APPENDIX G:
Responses to Comments

RE: Louisiana Coastal Area - Ecosystem Restoration Project Convey Atchafalaya River Water
to Northern Terrebonne Marshes and Multipurpose Operation of Houma Navigation Lock

ON THE DRAFT SUPPLEMENTAL ENVIRONMENTAL IMPACT STATEMENTS FOR THE SMALL DIVERSION AT CONVENT/BLIND RIVER; CONVEY ATCHAFALAYA RIVER WATER TO NORTHERN TERREBONNE MARSHES AND MULTIPURPOSE OPERATION OF HOUMA NAVIGATION LOCK; MEDIUM DIVERSION AT WHITE DITCH, AND AMITE RIVER DIVERSION CANAL MODIFICATIONS FOR THE LOUISIANA COASTAL AREA

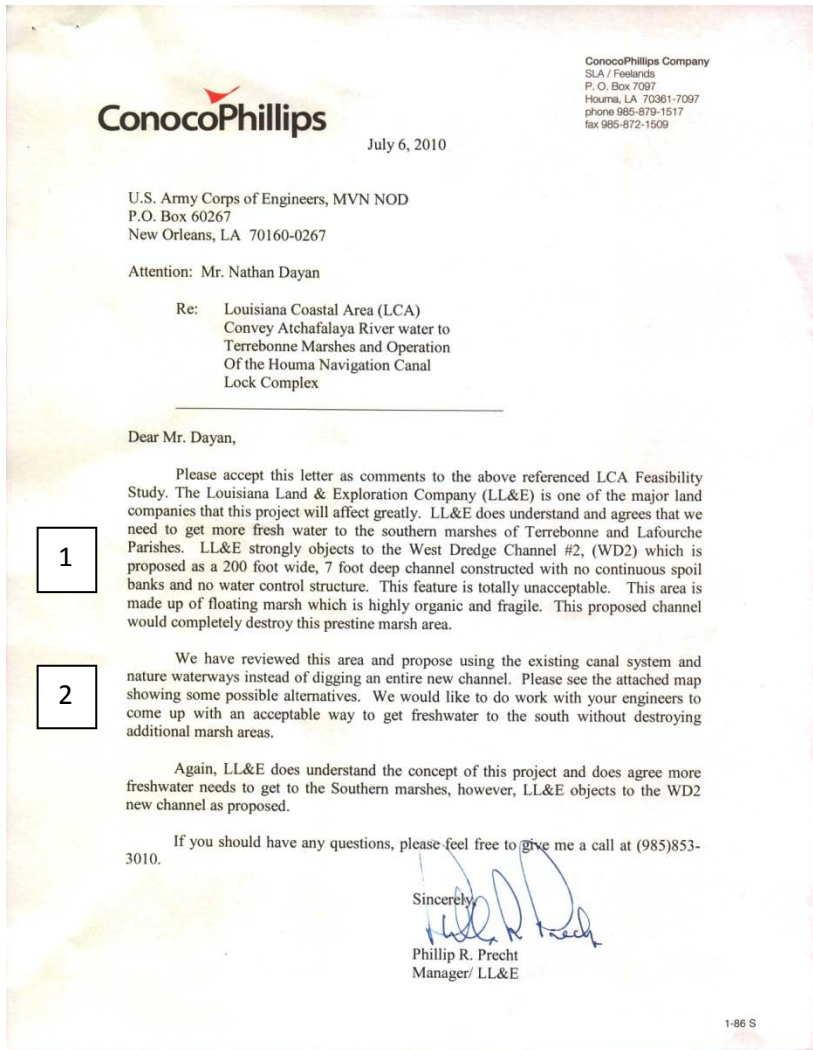
We have reviewed this area and propose using the existing canal system and nature waterways instead of digging an entire new channel. Please see the attached map showing some possible alternatives. We would like to do work with your engineers to come up with an acceptable way to get freshwater to the south without destroying additional marsh areas.

Again, LL&E does understand the concept of this project and does agree more freshwater needs to get to the Southern marshes, however, LL&E objects to the WD2 new channel as proposed.
